HISTORIC AND DESIGN REVIEW COMMISSION

June 05, 2019

HDRC CASE NO: 2019-315
ADDRESS: 310 CALLAGHAN AVE
LEGAL DESCRIPTION: NCB 721 BLK 3 LOT N 80.04 FT OF 3
ZONING: RM-4
CITY COUNCIL DIST.: 1
DISTRICT: Lavaca Historic District
APPLICANT: Justin Ferdinand/Alamo Wealth Builders, LLC.
OWNER: Justin Ferdinand/Alamo Wealth Builders, LLC.
TYPE OF WORK: Exterior modifications
APPLICATION RECEIVED: May 17, 2019
60-DAY REVIEW: July 16, 2019
CASE MANAGER: Huy Pham

1 SOUTH ELEVATION
Scale: 3/16" = 1'-0"
0 1 5 10
GRAPHIC SCALE

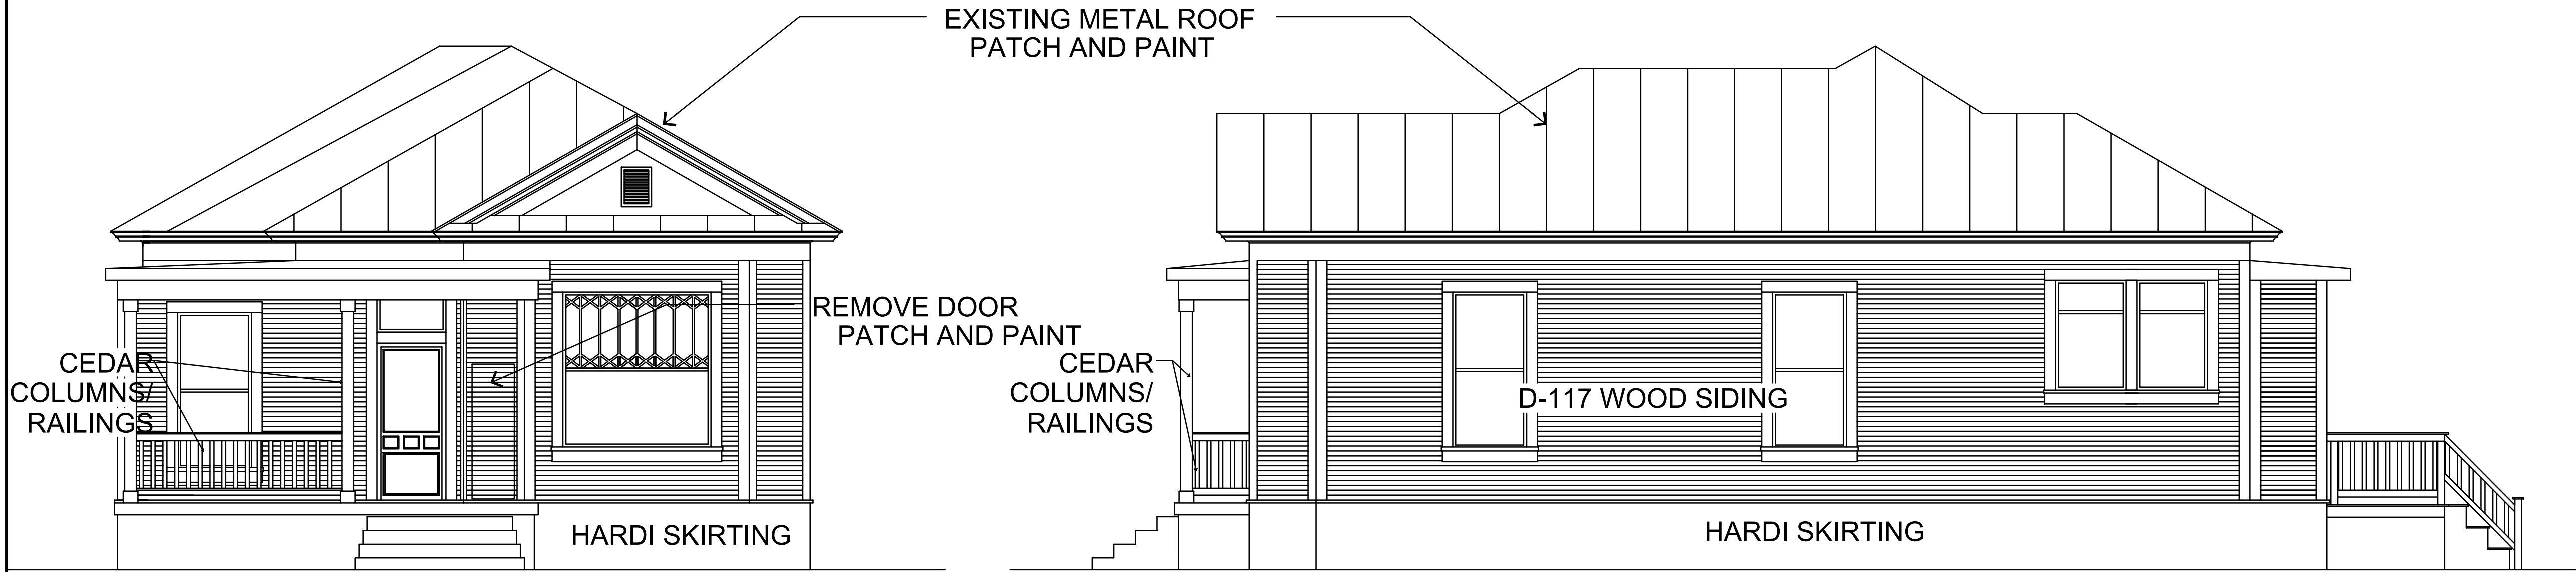
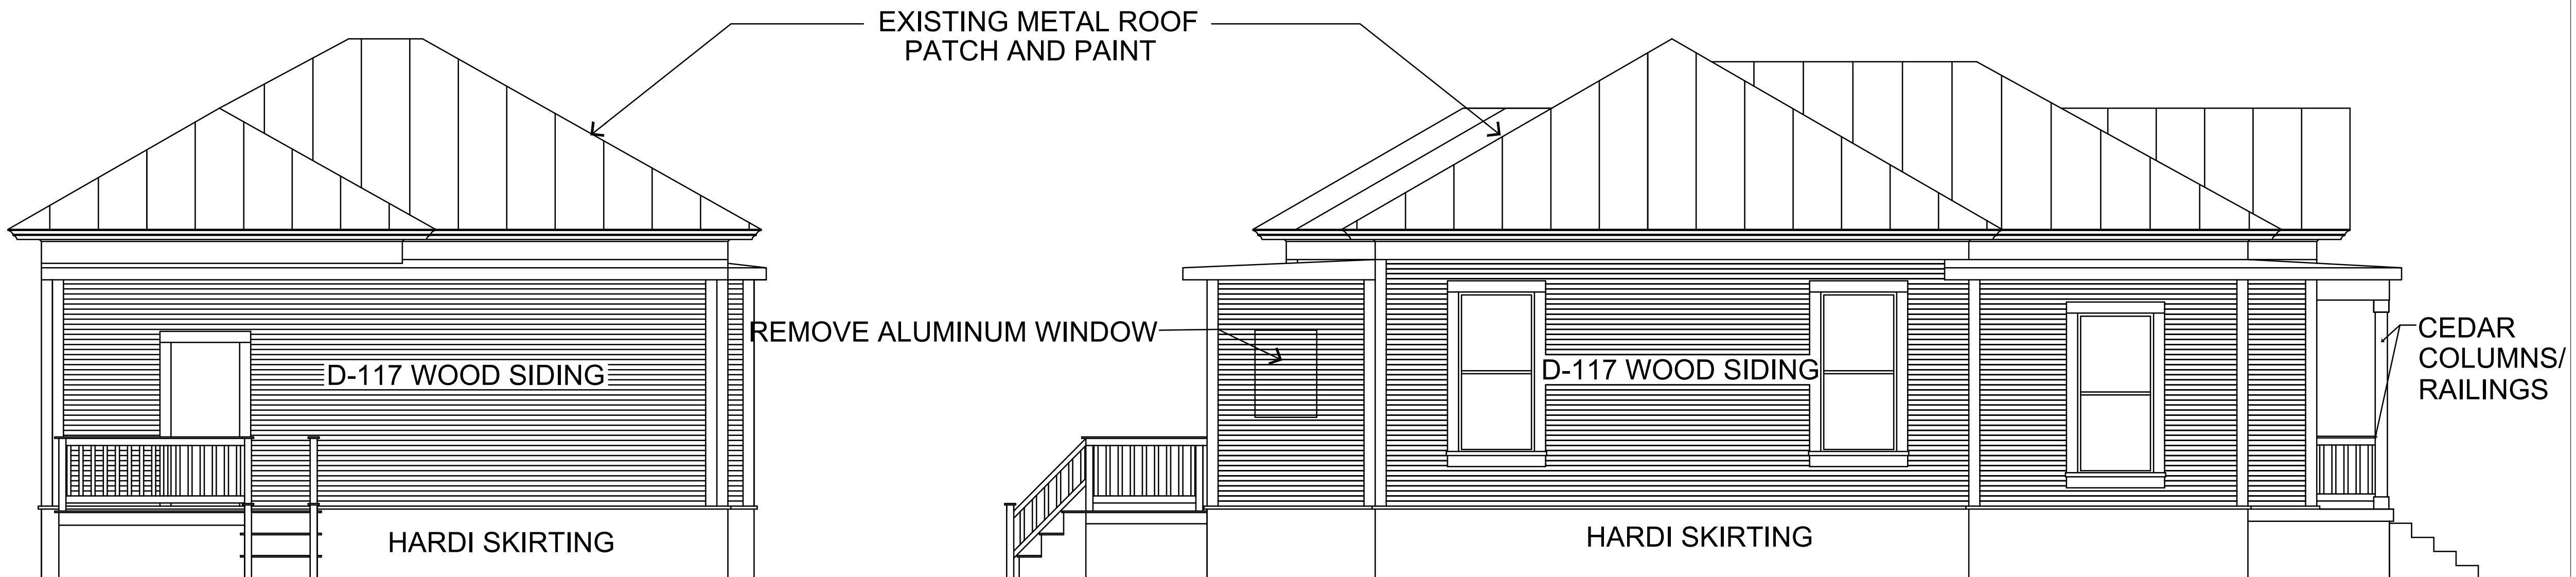
- e. REAR WINDOW REMOVAL FOR ADDITION & DECK – The applicant has proposed to install a three-foot by eleven-foot (3' x 11') rear addition flush to the existing rear-most wall plane. This addition requires the removal of an original window opening and wood window and includes the installation a rear wood patio deck. Staff finds that the proposed addition is generally appropriate regarding its massing, location, and materials. However, per the Guidelines for Additions 3.1.A.iv. and 3.3.C.i., staff finds that an inset wall plane and/or vertical trim piece is installed to distinguish between old and new forms and that the removed wood window be salvaged by relocating to another portion of the rear façade, respectively.

- h. FRONT DOOR REMOVAL – The applicant has proposed to remove the corner-facing front door to infill with siding. Staff finds the atypical location and orientation and the difference in door size, head height, and style to the other front door indicates that the corner-facing door is not original to the structure. Staff finds that the removal of the non-historic feature appropriate.

- i. FRONT DOOR RELOCATION – The application has proposed to relocate the front-facing front door approximately one-foot (1') closer to the bay window corner. The door and opening has been removed prior to approval and has been issued a Stop Work Order; the original door is still on site. Staff finds that the door opening including the original wood door and overhead transom is original to the structure and should be preserved in-place per the Guidelines for Exterior Maintenance and Alterations 3.6.A.i.

Request Item	Staff Notes	Action needed by applicant
Close off rear door and repair with new d117 siding to match existing	Requires HDRC hearing	rear elevation drawing, additional photos (see A2.0/3 & Image A, E)
Demo patio cover over existing rear door	May be eligible for admin, need to verify non-original status	additional photos (see Image A)
Remove kitchen window to rear to backyard and replace with front door	Requires HDRC hearing	rear elevation drawing, additional photos (see A2.0/3 & Image B)
install front wood door w new patio deck	Requires HDRC hearing	rear elevation drawing, additional photos (see A2.0/3 & Image B)
Restore 8 wood windows and install new wood screens	Requires HDRC hearing	Profile photo of each window, specifications for proposed windows, window schedule (see A2.0/1, 2, 3,4 & Image C)
install electric or solar gate with metal and or horizontal cedar	Requires HDRC hearing	Site plan with proposed fence line, elevation drawing or example photo of proposed fence (see A0.2/1 & Image D)

Remove bathroom window and close off with existing d117 siding	Requires HDRC hearing	Elevation drawing (see A2.0/4 & Image E,F)
Landscape front yard (NOT PROVIDED)	May be eligible for admin, need to maintain a majority of plant cover/lawn with no new hardscaping	Site plan with landscape elements
Concrete ribbon driveway with crushed gravel	May be eligible for admin if 10ft wide, pavers advised against	Site plan (see A0.2/1 & Image G)
and crushed gravel in backyard (NOT PROVIDED)	May be eligible for admin	Site plan
Remove metal railings to go back with cedar posts and handrails	May be eligible for admin, needs to match historic profile, can ask for staff specifications	Elevation drawing for proposed front porch (see A2.0/1 & Image H)
remove vinyl/aluminum siding on entire house to expose existing D117 wood Siding	May be eligible for admin, need to verify scope	Photo of exposed wood siding under current vinyl siding, rotten wood should be replaced with matching profile (see A2.0/1,2,3,4 & Image E, I)

remove right front door and repair with existing D117 Siding	Requires HDRC hearing	Elevation drawing of front façade (see A2.0/1 & Image E, H)
remove vinyl siding and repair 3" overlap siding (Repeated)	May be eligible for admin, need to verify scope	Photo of exposed wood siding under current vinyl siding, rotten wood should be replaced with matching profile
move left door to the right 12" and replace w existing wood door	Requires HDRC hearing	Elevation drawing of front porch, drawing or example photo of proposed new door. If removing historic door, needs to match. (see A2.0/1 & Image J, K)
repair 6' fence to the right with horizontal cedar	May be eligible for admin if rear fence only	Site plan with fence line (see A0.2/1)
demo dilapidated stand alone carport, demo shed on shared property	separate pending request by applicant Cameron Baker	
Continue fence build 8' ft fence on rear of property, 8' fence on rear dividing property lines would equate to 6' of privacy since house sits 2' above ground on pier and beam as permitted in city code, bringing enhanced value to the neighborhood to give proper privacy from neighbors.	Requires HDRC hearing, limit 6' in rear and 4' in front	Site plan with fence line (see A0.2/1 & Image L)

- i. All new wood siding should feature a 117 profile
- ii. The rear wood window removed for the addition and patio should be salvaged and relocated to another portion of the rear elevation.

Staff does not recommend approval of item 7, relocating the front door , or item 12, demolishing half of a shared rear accessory structure.
